SUBJECT: AMENDMENT NO. 80 TO FACILITY OPERATING LICENSE NO. NPF-3;
CYCLE 5 OPERATION

DAVIS-BESSE NUCLEAR POWER STATION, UNIT NO. 1

Amendment No. 80
License No. NPF-3

SAFETY EVALUATION BY THE OFFICE OF NUCLEAR REACTOR REGULATION
SUPPORTING AMENDMENT NO. 80 TO FACILITY OPERATING LICENSE NO. NPF-3

Figure 3.1-5a APSR Position Limits, 0 to 25+10/-0 EFPD,
Four RC Pumps -- Davis-Besse 1, Cycle 5

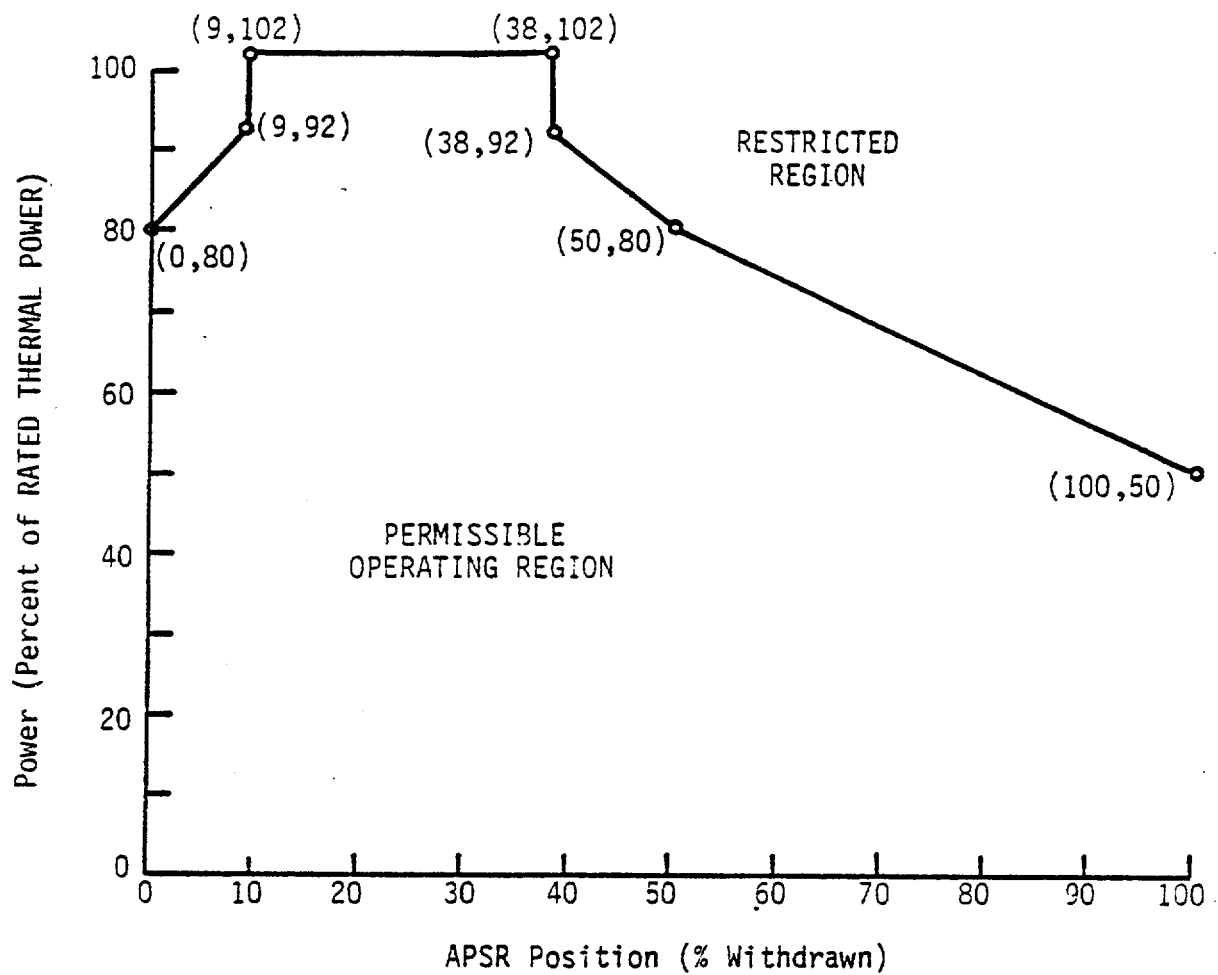
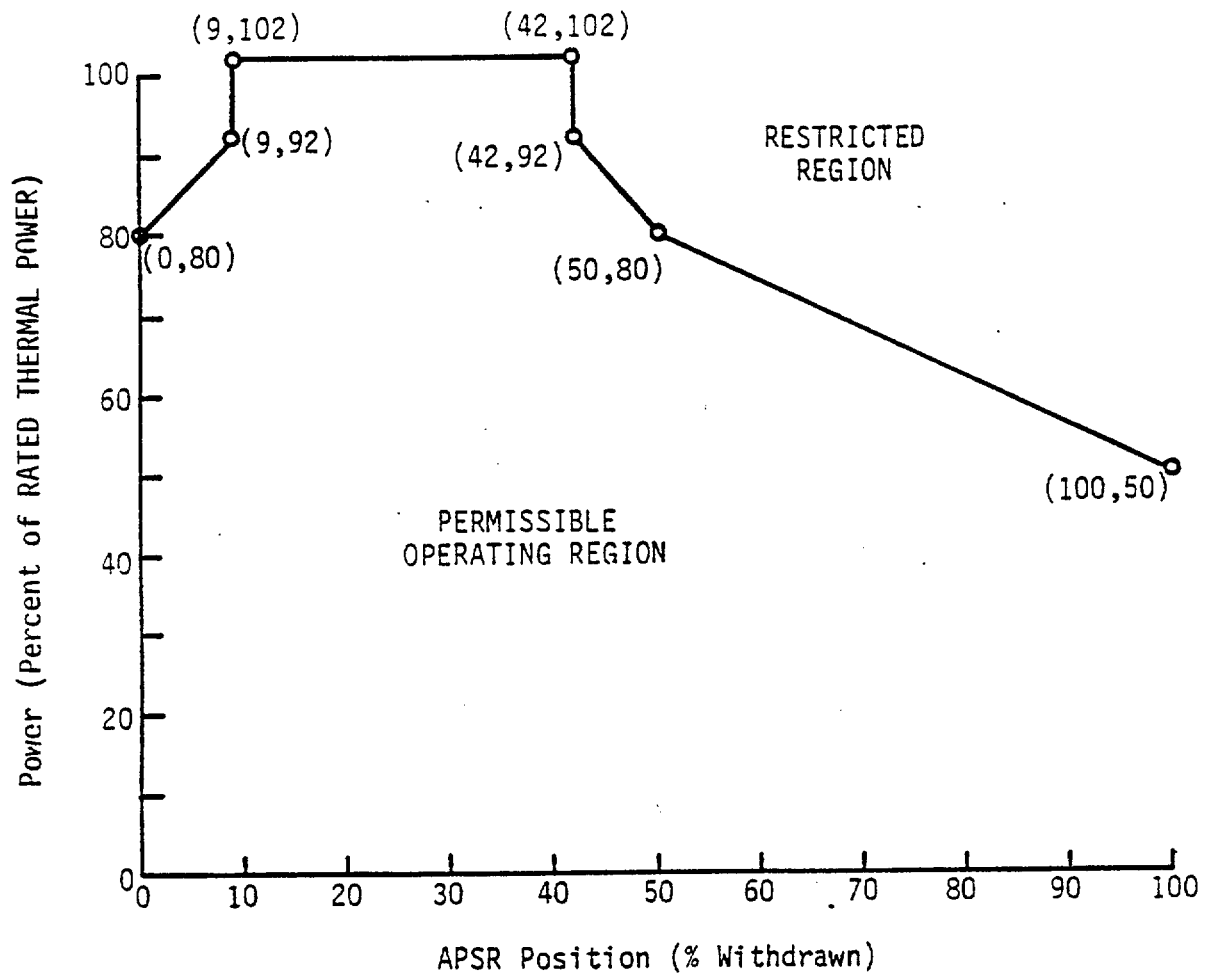
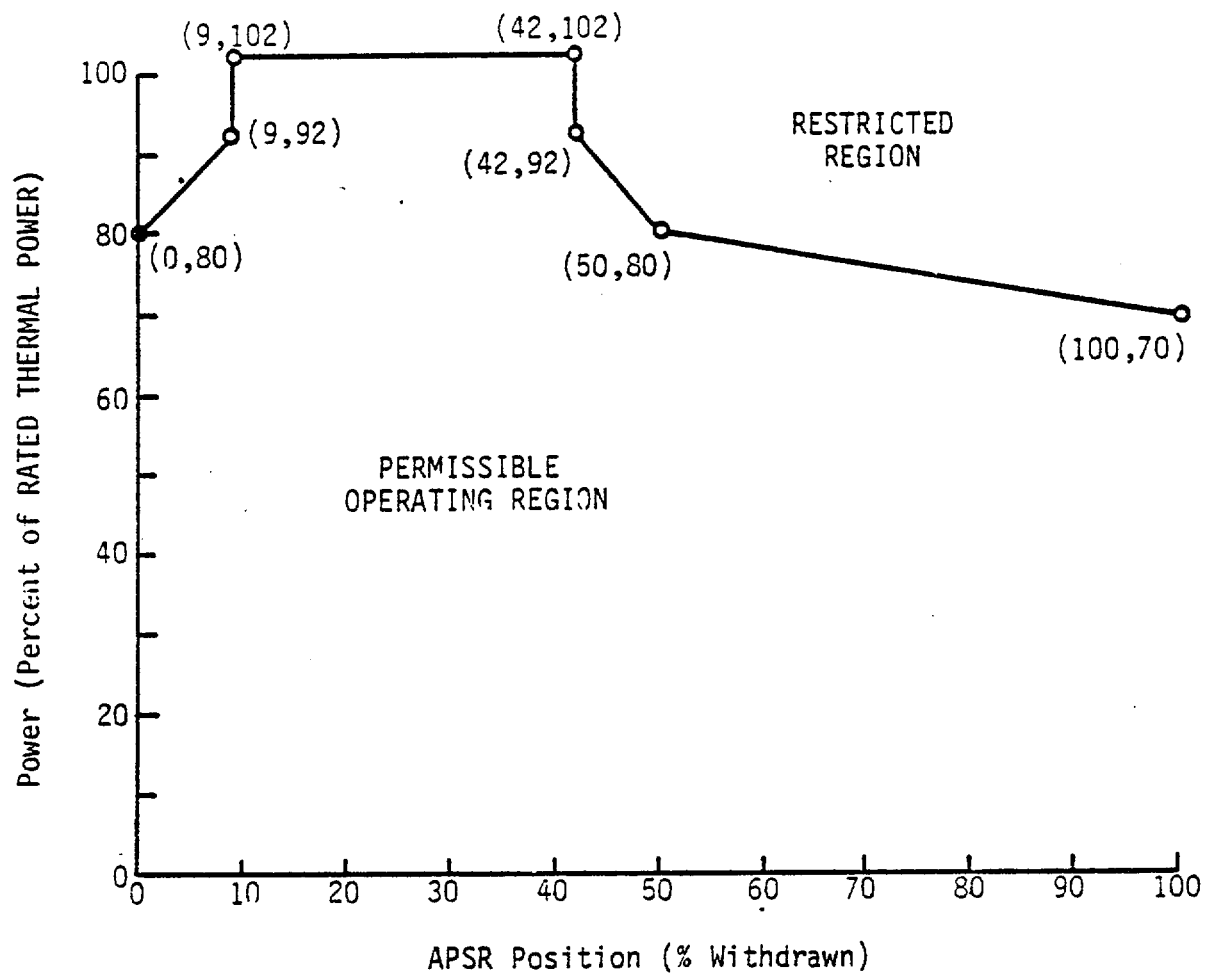
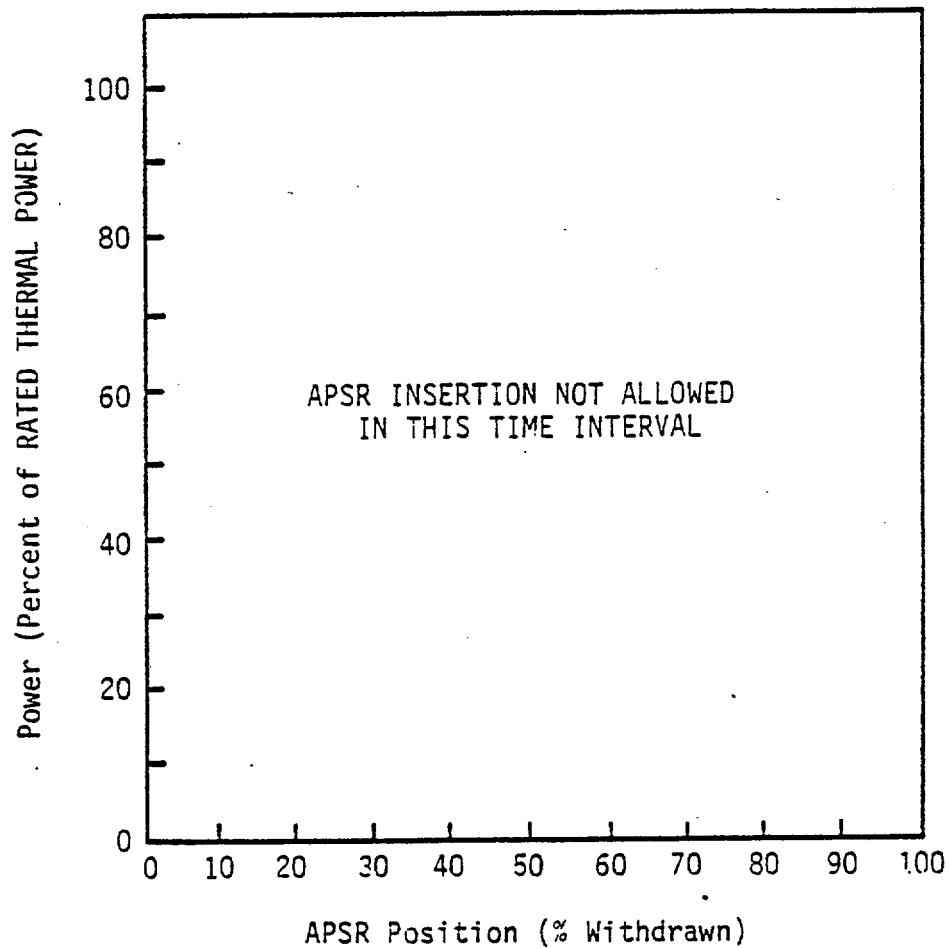
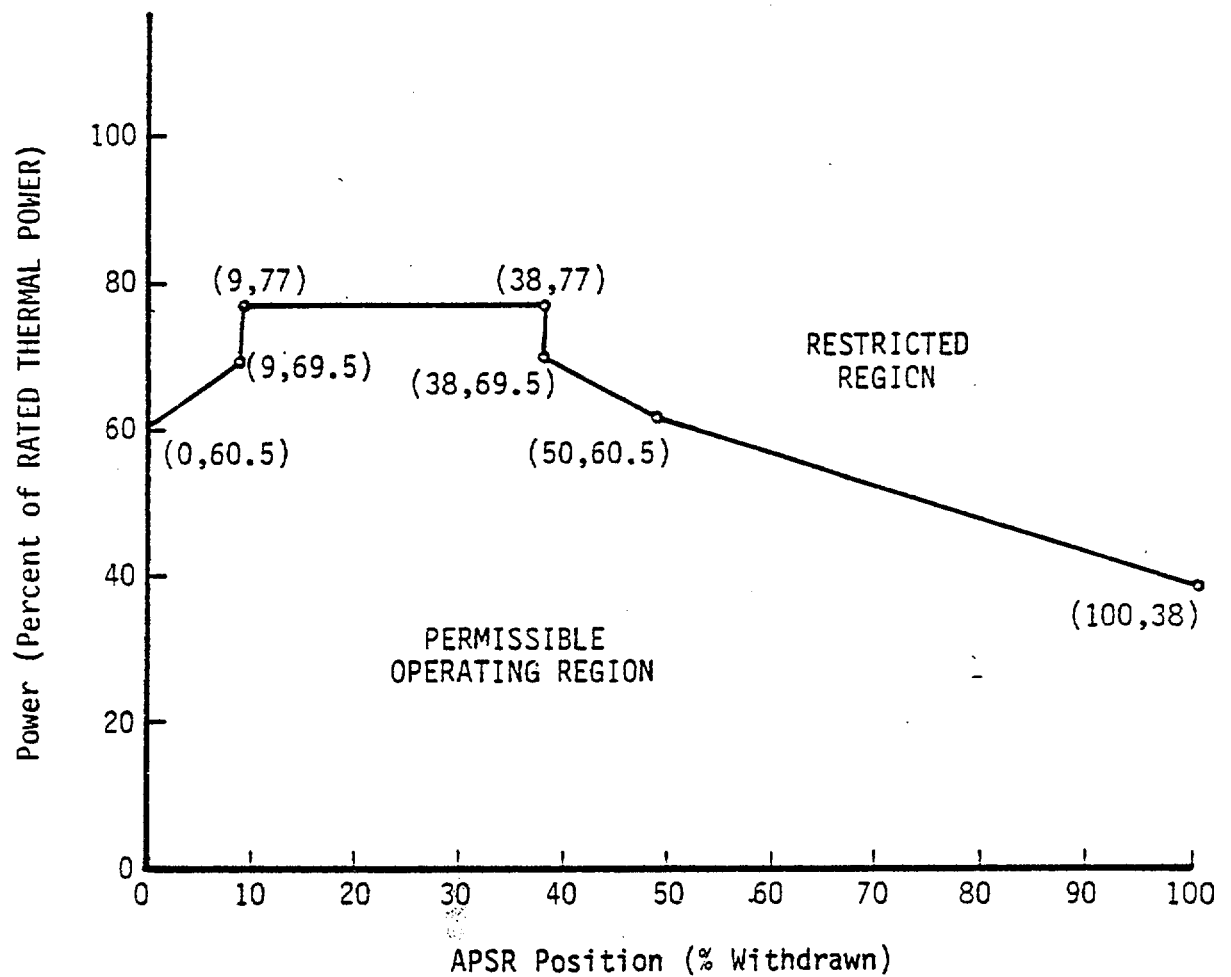
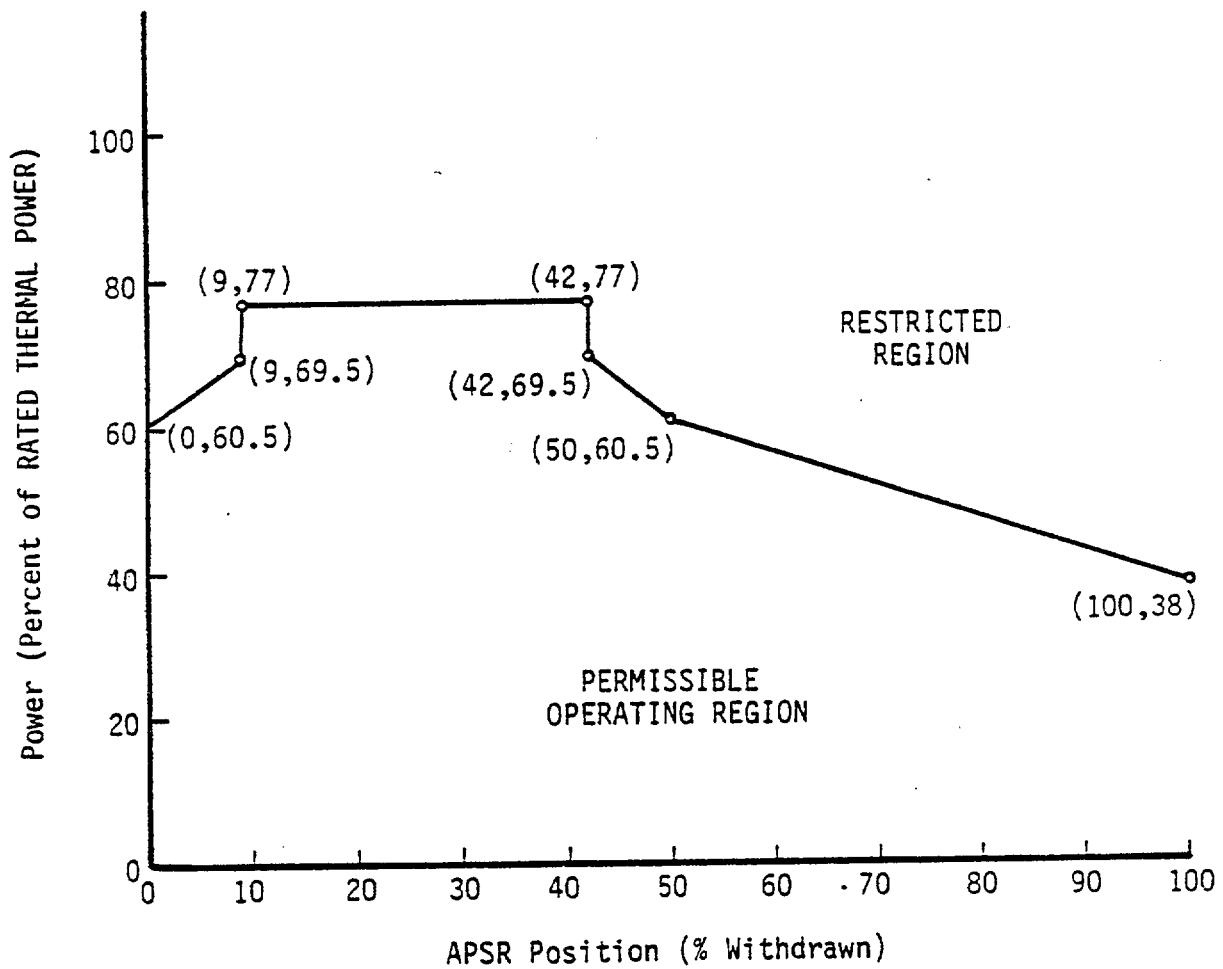
3.1.3.9 The axial power shaping rod group shall be limited in physical insertion as shown on Figures 3.1-5a, -5b, -5c, -5d, -5e, -5f, and -5g.

Axial Power Imbalance Limits, 0 to 25+10/-0
EFPD, Four RC Pumps -- Davis-Besse 1, Cycle
5

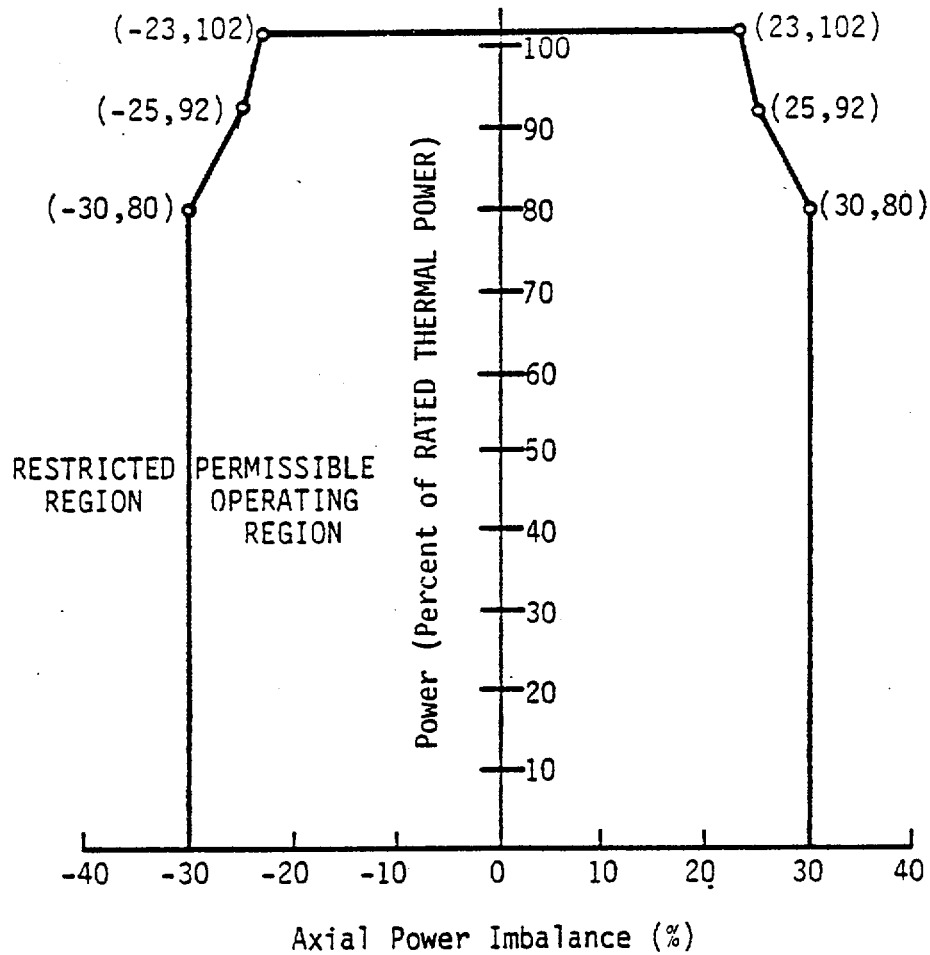
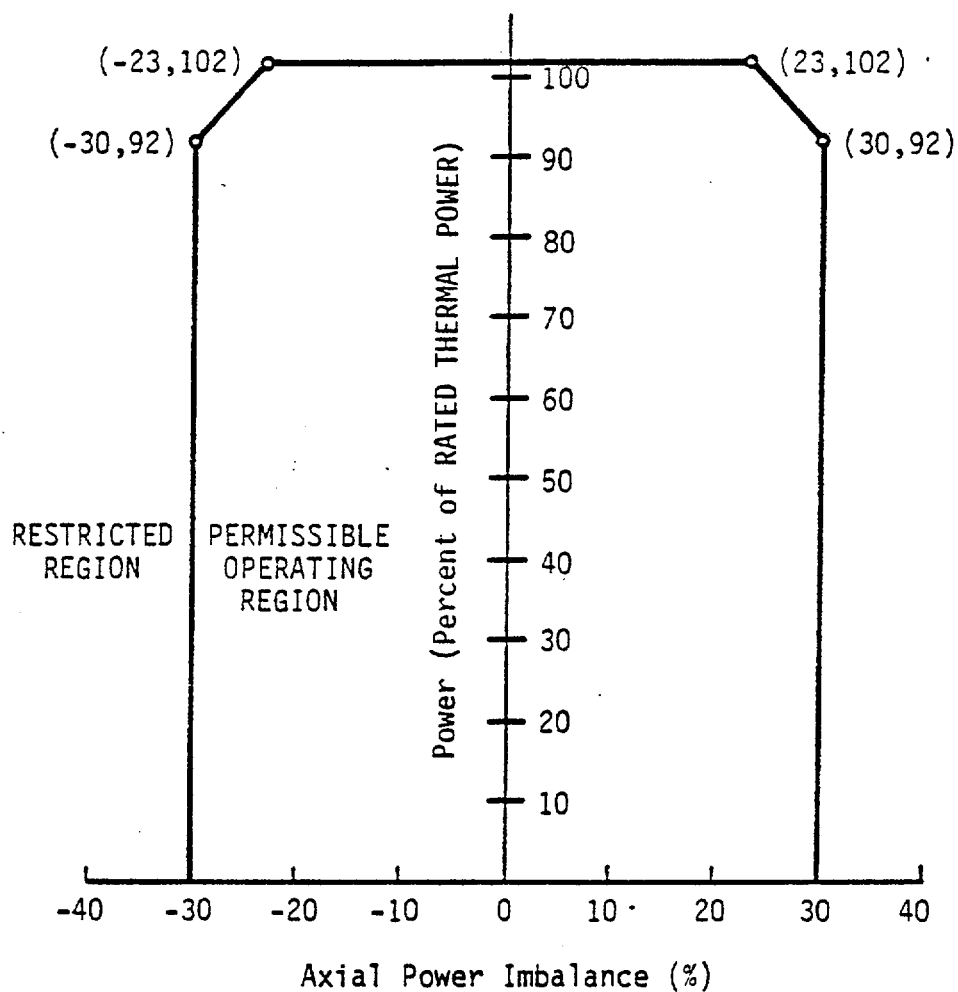
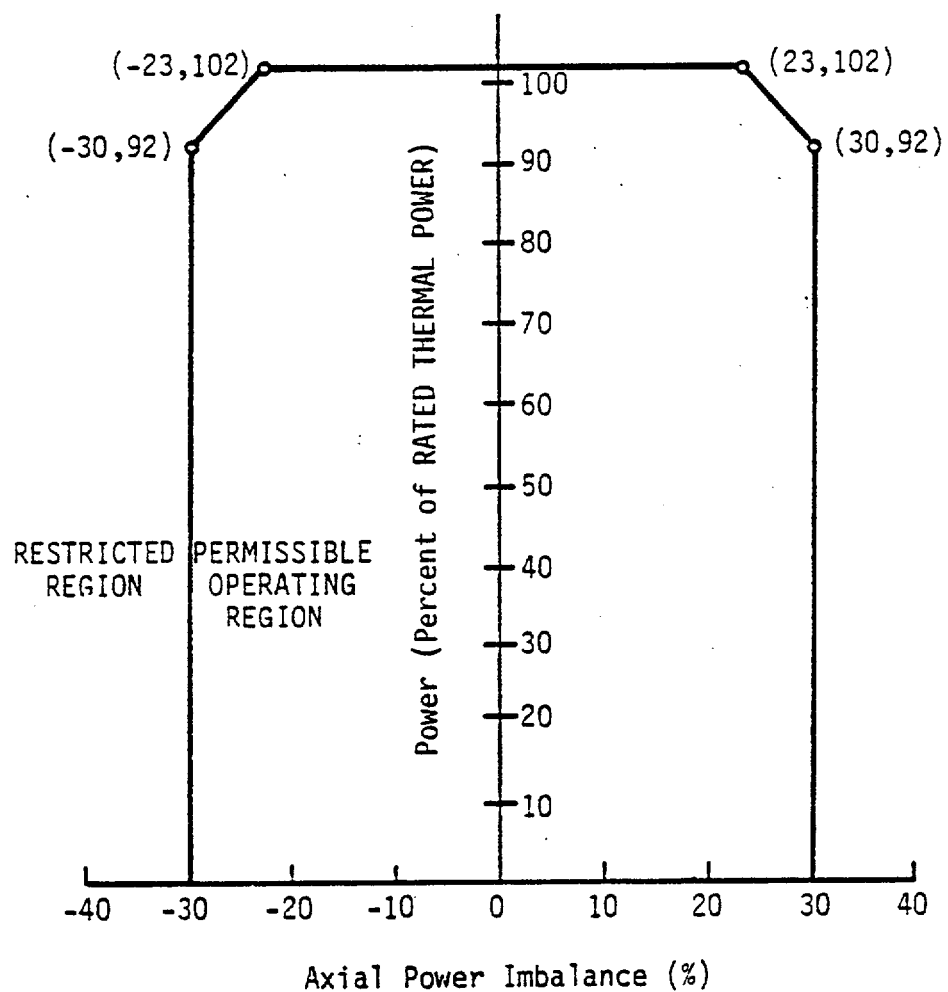
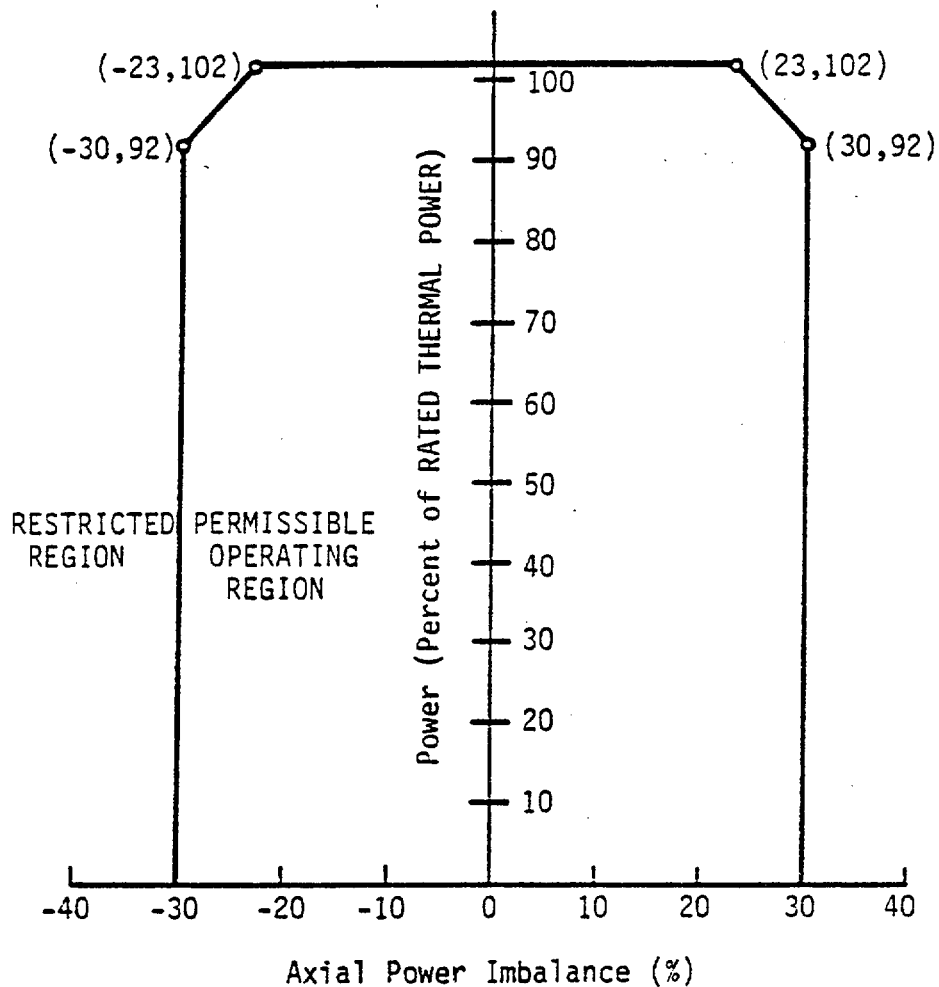
3.2.1 AXIAL POWER IMBALANCE shall be maintained within the limits shown on Figures 3.2-1a, -1b, -1c, and -1d and 3.2-2a, -2b, -2c and -2d.
